Appendix 5: Tasman District Council Development Engineer Assessment

MEMORANDUM

RE: Plan Change 73: Omnibus 2 Amendments – Indicative Roads

A Johnston No 1046 – Remove the existing indicative road off his property and relocate to other properties (see plan below). Remove proposed indicative road connecting to Holer Industries property.

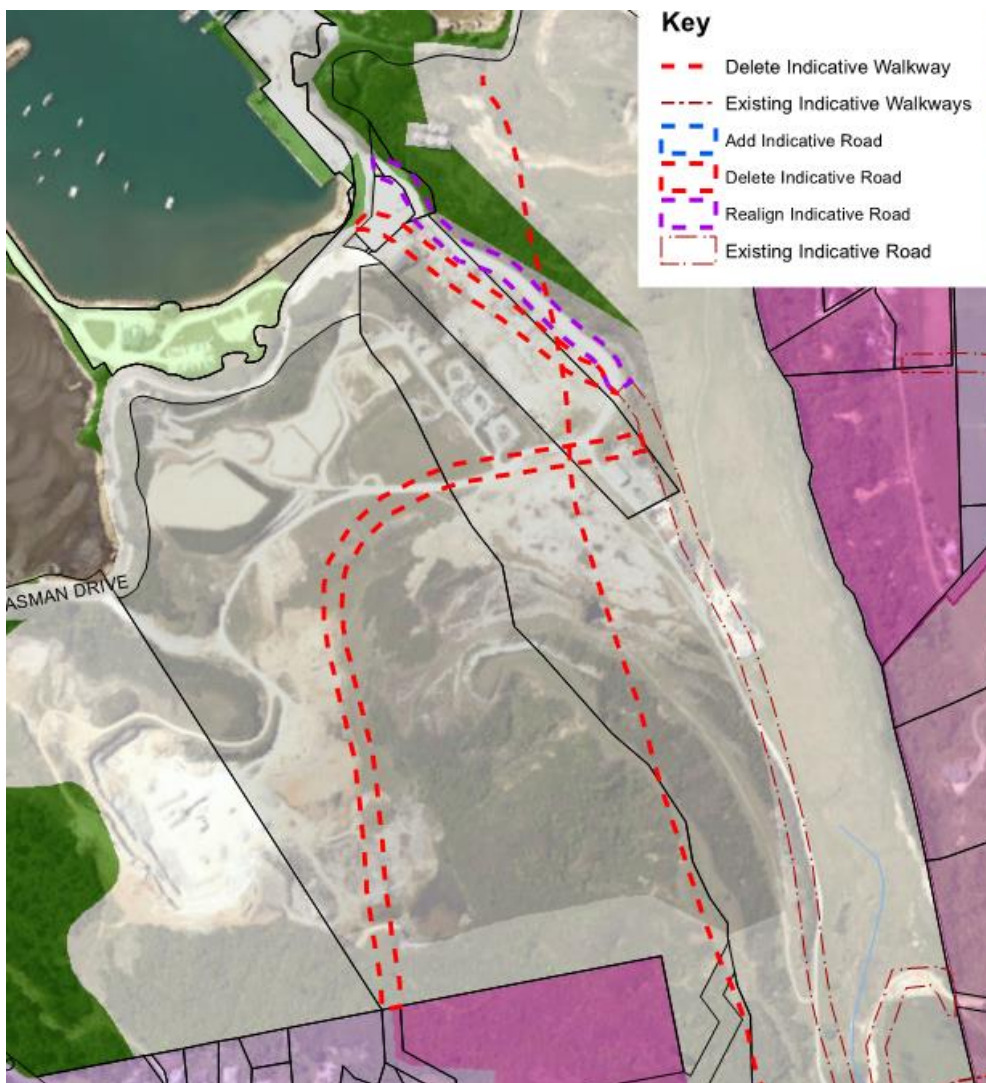
The boundary buffer between the zones was to be the 25m wide stormwater drainage designation (D247) known in this area as the Reed Andrews stream (shown as “Proposed Drain” in the Johnston plan above). That 25m has 4m placed on the “Holer” property (rural zoned and where the existing stream is located) and 21m on the Johnston property.

Plan Change 73 does not alter this previously consulted on and existing indicative road. It is noted also that a further submission objects to the suggestion of Johnston that the road be relocated onto their property (see submission 3417). I agree with the further submission that the relocated indicative road suggested by the submitter will direct vehicles up to Paton Road and then likely more into the middle and through the Richmond CBD rather than directing them to the state highway network

The Future Development Strategy (FDS) and an IAF funding application is signalling that Richmond south will develop for residential out to Whites Road. Again, to enhance road connections and links, an indicative road stub is shown in this Plan Change 73. This is shown as a blue dotted line over the stormwater designation D247 and aligns with an existing stormwater channel from Whites Road that connects with the Reed Andrews stream.

This alignment (stub) is in line with the Nelson Tasman Land Development Manual (LDM) in that public infrastructure (in this case an existing stream/farm drain modified to accommodate stormwater flows and improved recreational and environmental outcomes) should be contained within roads or public property and that roads are the preferred locations for secondary stormwater flow paths. There is no loss of land to the property owners as the land is previously designated for stormwater drainage purposes.

This indicative road (a culvert required over the stormwater designation) will give access to that adjoining property to the south – the “Holer” property on the submitter’s map. This can allow that property to be developed early (**if they fund/build the road/culvert**) rather than relying on properties in Whites Road to then provide access and services (i.e., developing from the bottom up for gravity services).

The recommendation is therefore that the Johnston submission be declined.

D T King (4188) and A Mclean (4192)

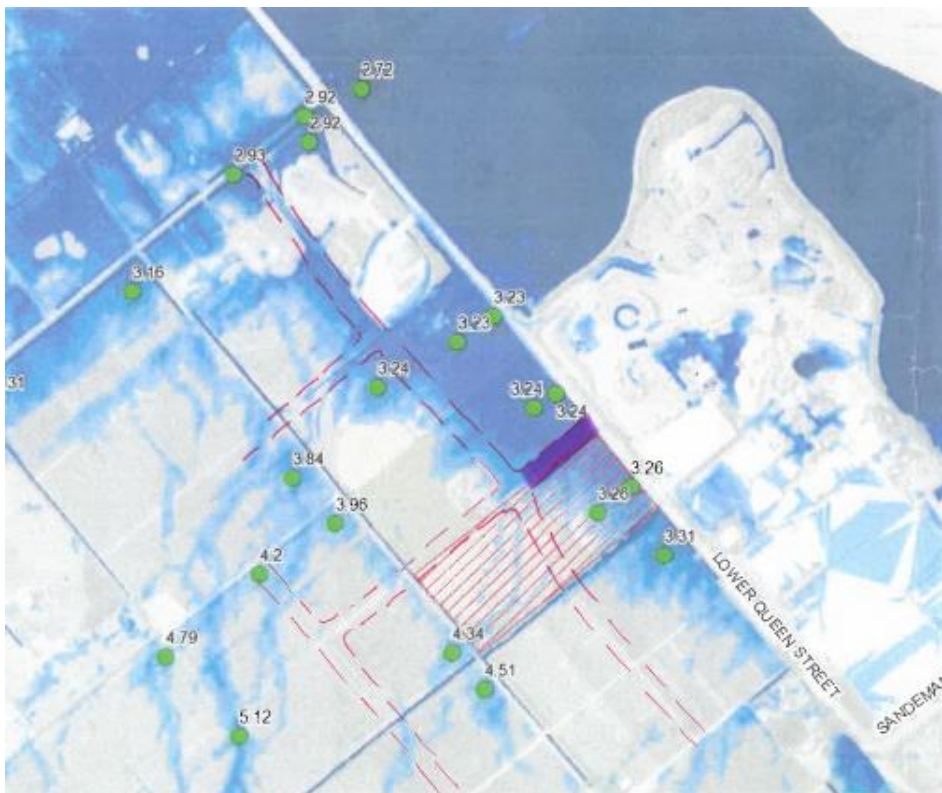
Recent modelling (see blue areas below - future climate change inundation predictions - 1% AEP and 1m sea level rise) in this location has shown several of the properties will become inundated and unilateral filling of the sites will potentially cause flooding to be directed to other properties.

One of the indicative roads (purple shading above) (number 551 Lower Queen Street shown with red lines) was proposed to be co-located between these two properties and shown on the submitter's maps. This new road, if formed, will become regularly inundated in the future, together with the services located within it.

The Community Services Group Manager and Transportation Manager agreed that this is too much of a risk for this Council to bear and costs to future ratepayers. The area is well served by indicative roads especially to the south and inland from LQS and therefore less susceptible to climate change and sea level rise. The result being the proposed removal of this section of indicative road. The two existing access connections to Lower Queen Street via McShane's Road and Swamp Road are deemed to provide adequate servicing ability in the long term.

I therefore recommend that the submissions be declined, and the short section of indicative road starting at LQS be removed from the planning maps.

(e) Indicative Road

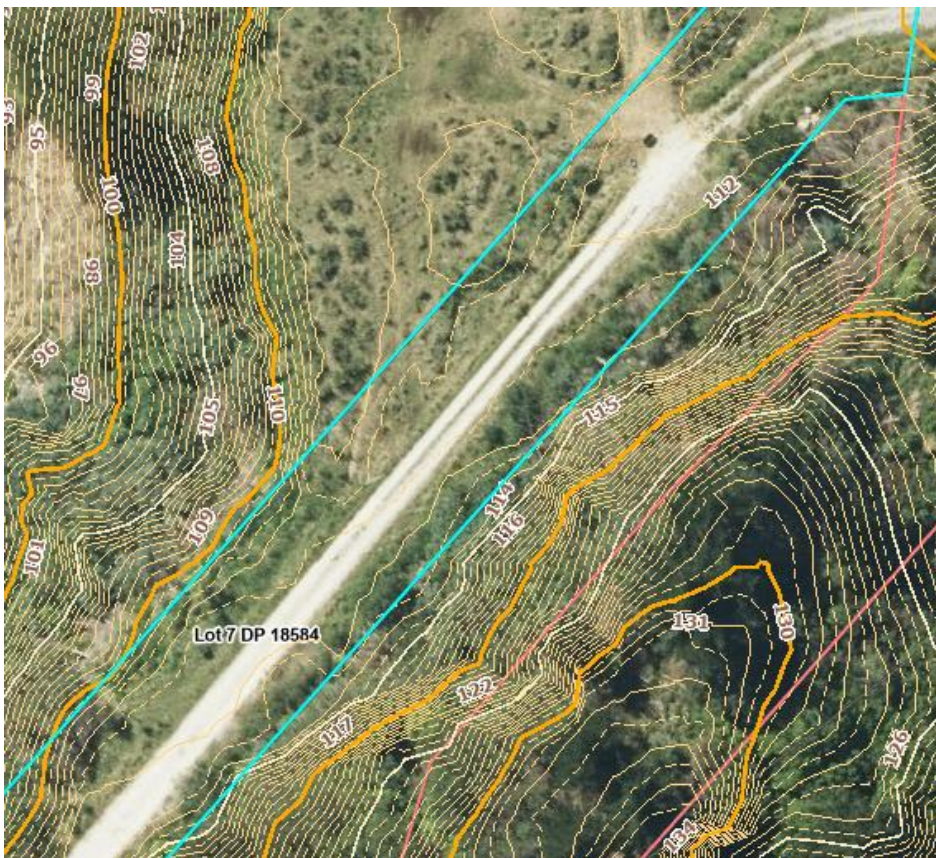
There is an indicative road shown on the TRMP maps over the ROW (Lot 7 DP 18584). This road is an alternative access from Pohara to Ligar Bay that could provide future connectivity should the coastal road between these two settlements ever be compromised. Easement Instrument 390595.5 registered on Lot 6 DP 18584 relates to the ROW and includes maintenance requirements. It contains a provision that the ROW will be extinguished when required to allow for the creation of a legal road, and that the owners will surrender their interest in the ROW when called upon by Council. This easement instrument will be registered on the new titles so that the rights and responsibilities of the ROW transfer to the new owners. This aims to prevent any future disagreement over the use or taking of the ROW by Council.

During this process Council Engineering staff were approached by Matenga West with the opportunity to purchase the ROW, however this matter is considered outside and separate to the subdivision application and decision-making process. The applicant also highlights that the dwelling on proposed Lot 2 does not meet the permitted activity setbacks to a road (should the ROW ever become a road) and acknowledges that this is an existing situation that will remain unchanged by the proposal.

RM070197

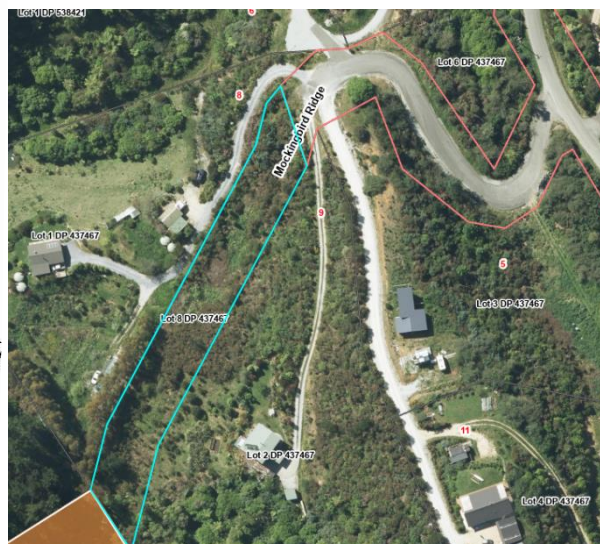
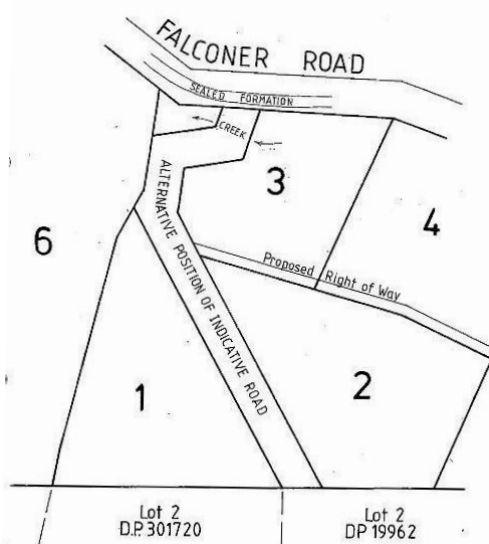
A subdivision application RM070197 in 2007 reassessed the future roads in the area and an application as below was accepted by Council. This created a formed road to vest (Mockingbird Ridge) and a future road reserve to the submitter's eastern boundary, in Council ownership. The indicative road further to the south on Falconer Road through to Haile Lane was then not required.

It is likely a complying road can be formed along this alignment to Haile Lane (via existing indicative roads) but will require cuts and fills and a culvert crossing.

This alignment as described above is the most cost-effective route with at least half of the route already in Council ownership for the new road link.

I therefore recommend that the submission be declined. It is noted that this indicative road is only likely to be formed when the current or future owners of that parcel of land decide to develop and/or subdivide.

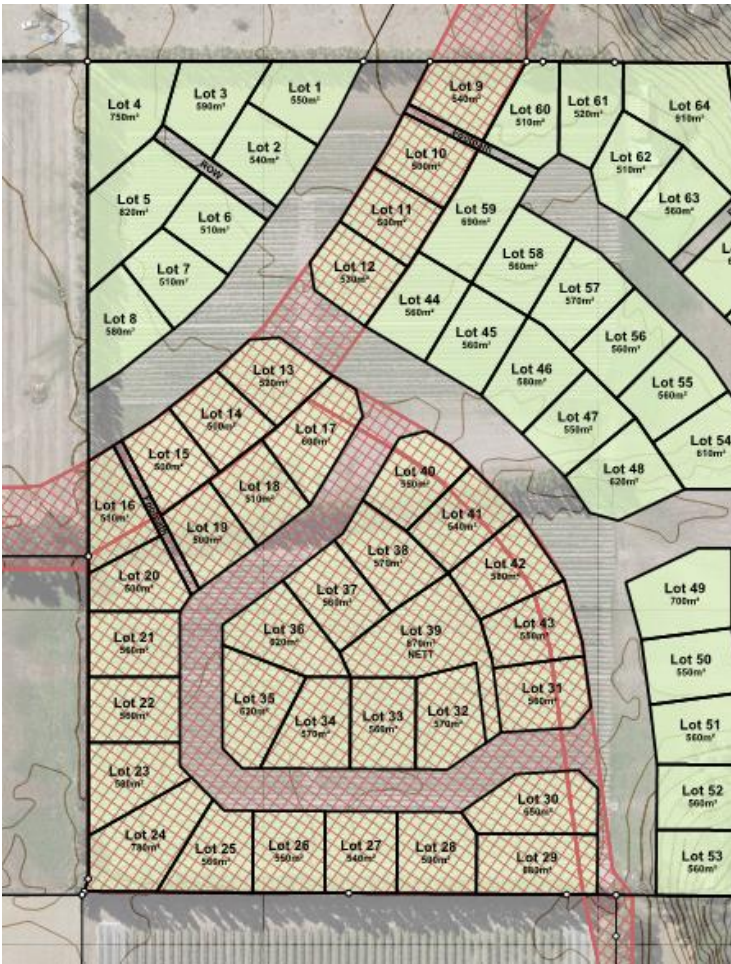
In 2017, Council set about investigating infrastructure projects in this catchment and arranged for borehole tests to be undertaken on the Batton land (Cardiff) for the potential shallow detention dam design - D248.

The Engineer’s final report outlined that a large detention area in that area would not be feasible due to extremely high ground water levels and in some test holes the groundwater came to the surface.

At that time, the shallow detention basin idea was abandoned and, along with it, the future recreation grounds. The process to remove this designation D248 from the planning maps has not progressed due to staff shortages and being of a low priority.

I therefore recommend that the submission be declined. A simple agreement as mentioned in this report that allows access over the designation in any area on the applicant's land will not unreasonably be withheld by Council, subject to suitable and appropriate design.
